RENESAS TECHNICAL UPDATE

Product Category	MPU/MCU		Document No.	TN-RX*-A137A/E	Rev.	1.00
Title	Errata to RX230 Group, RX231 Group User's Manual: Hardware		Information Category	Technical Notification		
Applicable Products	RX230 Group , RX231 Group	Lot No.	Reference Document	RX230 Group, RX231 Group User's Manual: Hardware Rev.1.00 (R01UH0496EJ0100)		
		All

This document describes additions of electrical characteristics and corrections to the RX230 Group, RX231 Group User's Manual: Hardware Rev.1.00.

Figure 50.13 VOH/VOL and IOH/IOL Voltage Characteristics at Ta = 25°C When High-Drive Output is Selected (Reference Data) is corrected as follows:

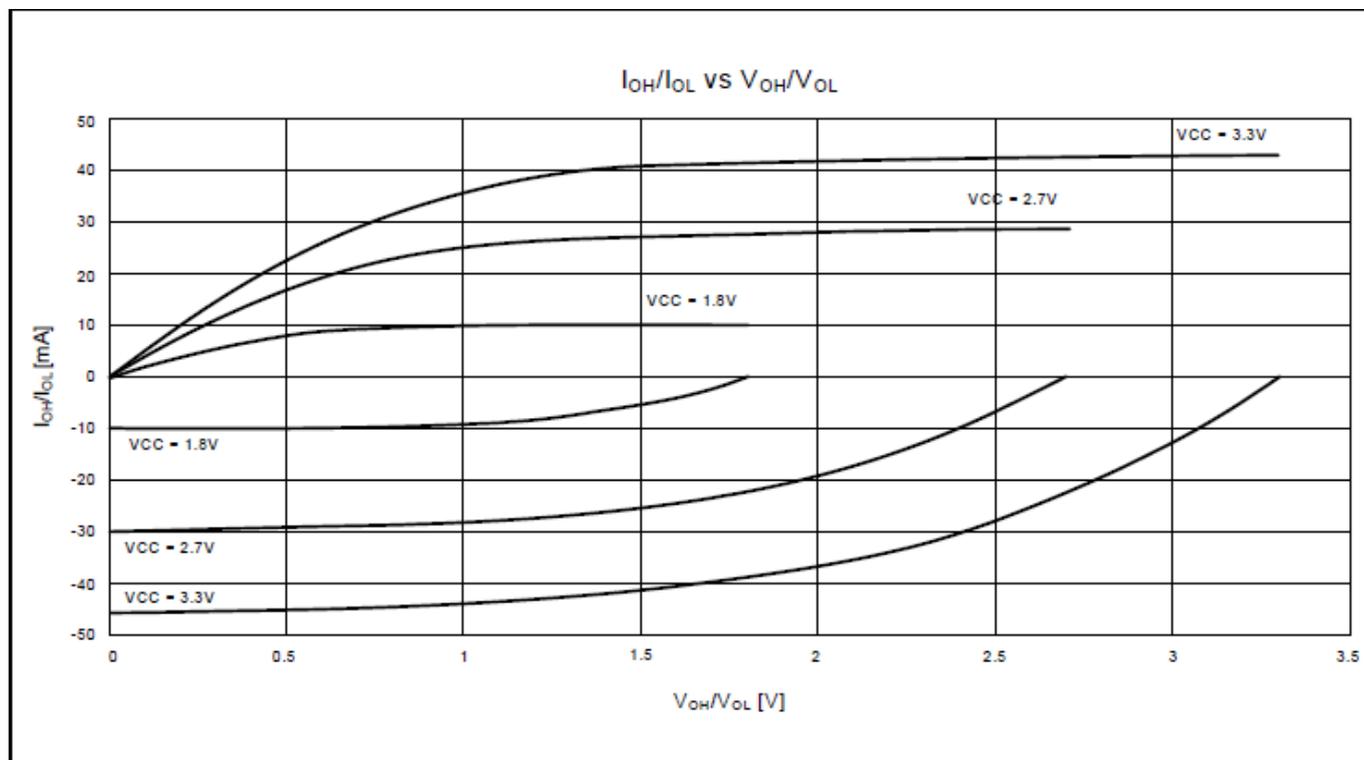
[Before correction]

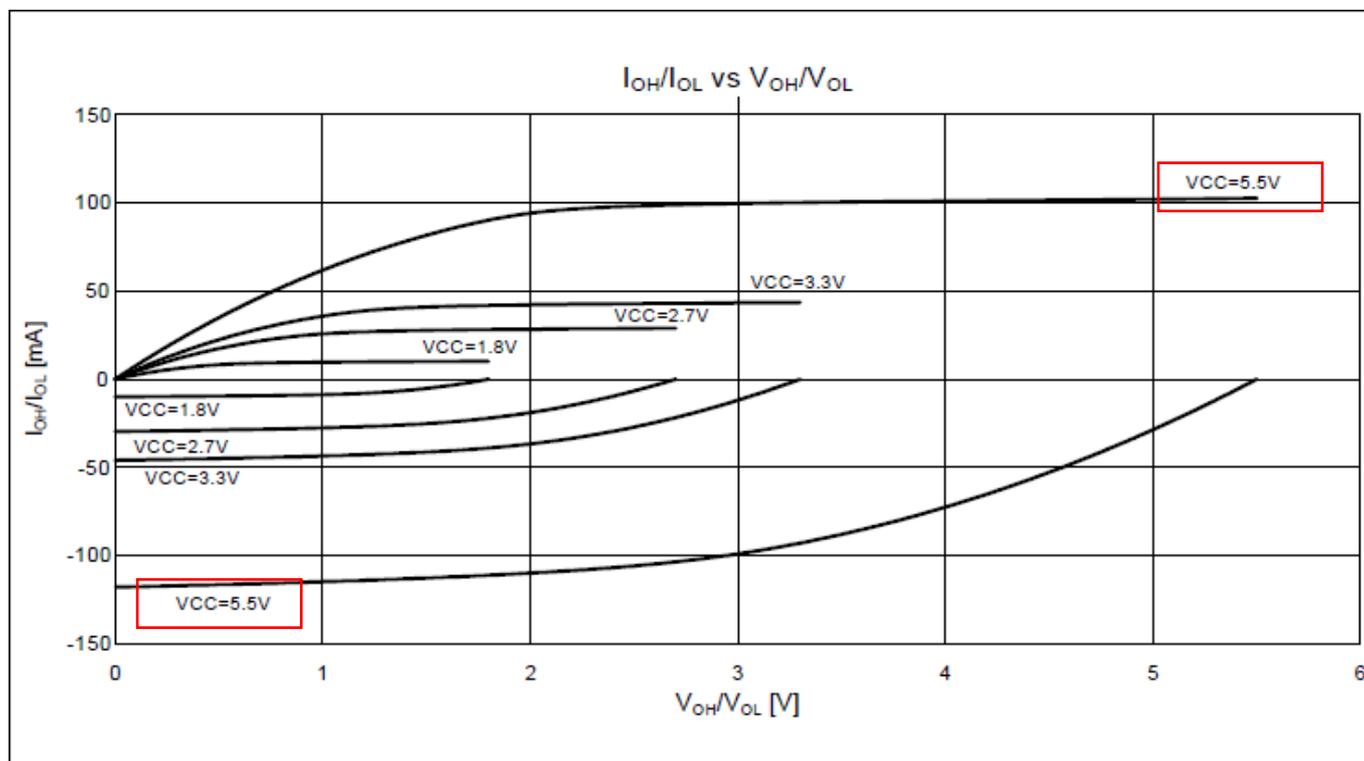
[After correction]

Figure 50.18 VOL and IOL Voltage Characteristics of RIIC Output Pin at Ta = 25°C (Reference Data) is corrected as follows:

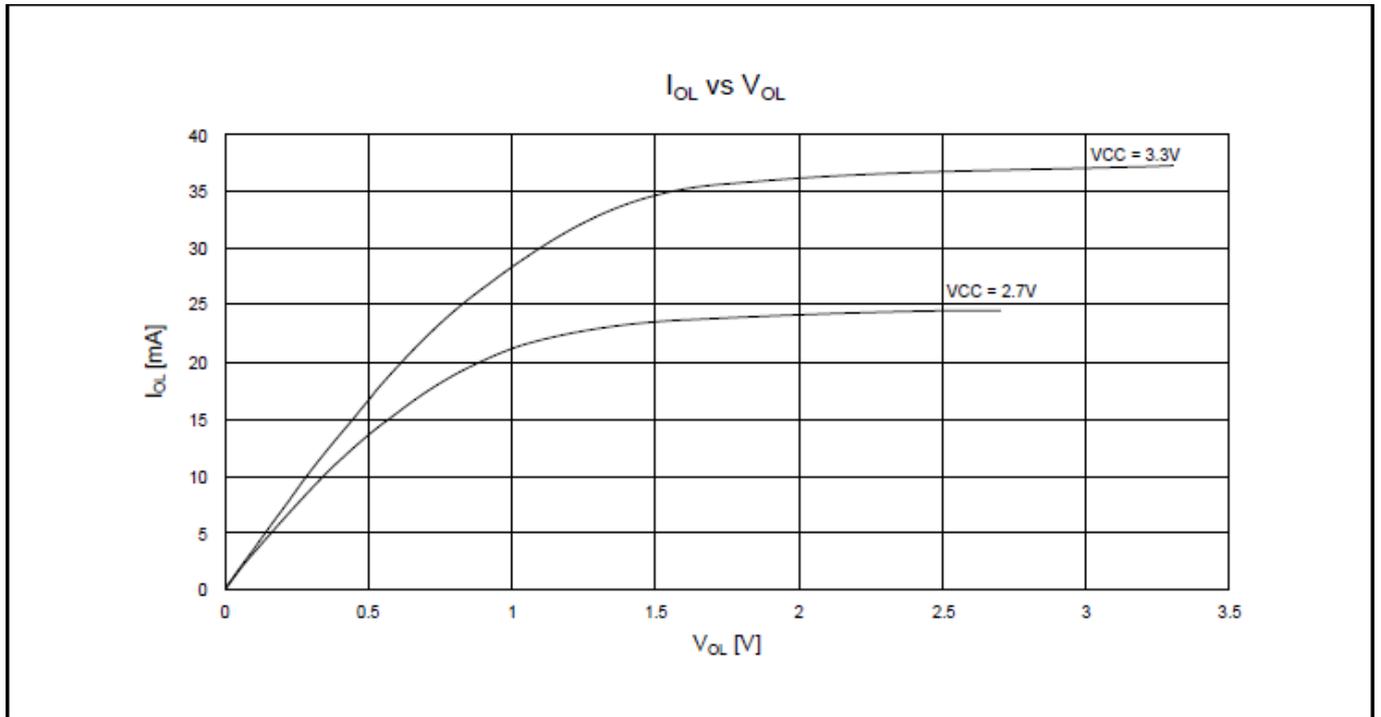
[Before correction]

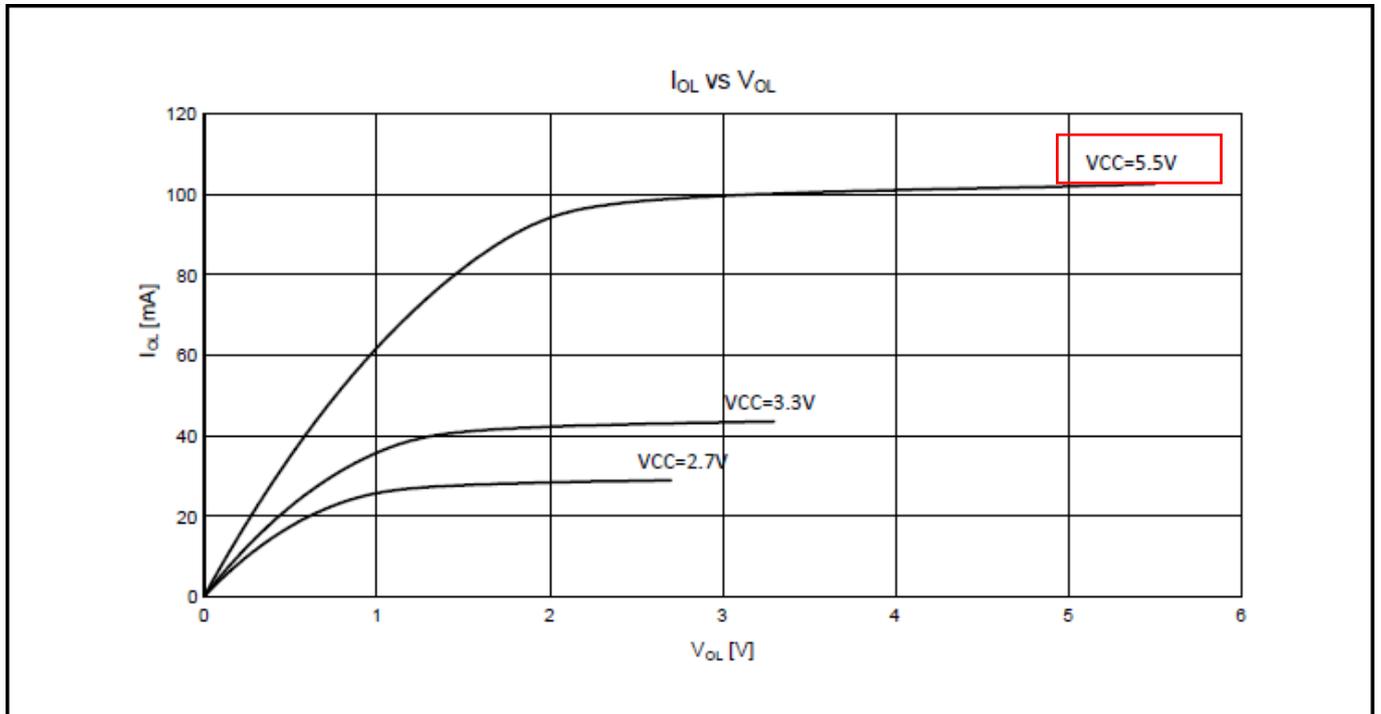
[After correction]
